**Economic Commission for Europe****Inland Transport Committee****World Forum for Harmonization of Vehicle Regulations****Working Party on General Safety Provisions****125th session**

**Amendments to Safety Glazing Regulations:****UN Regulation No. 43 (Safety glazing)****Proposal for Supplement 11 to the 01 Series of Amendments  
to UN Regulation No. 43 (Safety glazing)****Submitted by the expert from the Republic of Korea \***

**Figure 22**  
**Determination of Zone I**

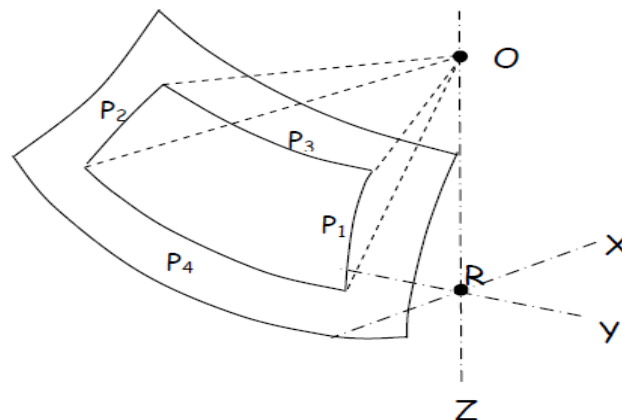
*Paragraph 9.2.5.2.3, amend to read and insert a new figure 22:*

**In addition, opaque obscuration can be exempted in Zone I. It is the limited areas where it is intended that a sensing device, e.g. a rain-drop detector, rear view mirror or autonomous sensors, will be bonded to the inner side of the windscreen. The opaque obscuration where such devices may be applied is defined in paragraph 9.2.5.2.4. of this Annex.**

"9.2.5.2.3. Zone I is the windscreen zone determined by the intersection of the windscreen with the four planes defined below:

P1 – A vertical plane passing through 0 and forming an angle of 15° to the left of the

P2 – A vertical plane symmetrical to P1 about the median longitudinal plane of the vehicle.

P3 – A plane passing through the straight Line OQ and forming an angle of 10° above the

P4 – A plane passing through the straight Line OQ and forming an angle of 8° below the

**Figure 23**  
**Zone I (example of a left-hand steering control vehicle)**  
**(Upper obscuration area as defined in paragraph 9.2.5.2.4.1.)**

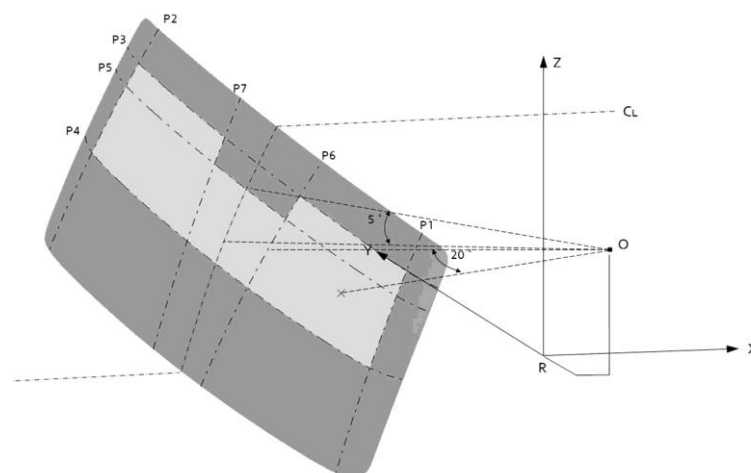
Insert new paragraphs 9.2.5.2.4., to 9.2.5.2.4.1., amend to read and insert a new Figure 23:

**9.2.5.2.4. Determination of the opaque obscuration**

**P5 – a plane passing through a transverse horizontal line containing O and forming an angle of 5° above the horizontal plane**

**P6 – a vertical plane passing through O and inclined at 20° to the right of the X axis in the case of left-hand drive vehicles and to the left of the X axis in the case of right-hand drive vehicles.**

**P7 – a plane symmetrical to P6 in relation to the longitudinal median plane of the vehicles.**

**9.2.5.2.4.1. Any opaque obscuration bounded downwards by P5 and laterally by P6 and P7. (See figure 23)**
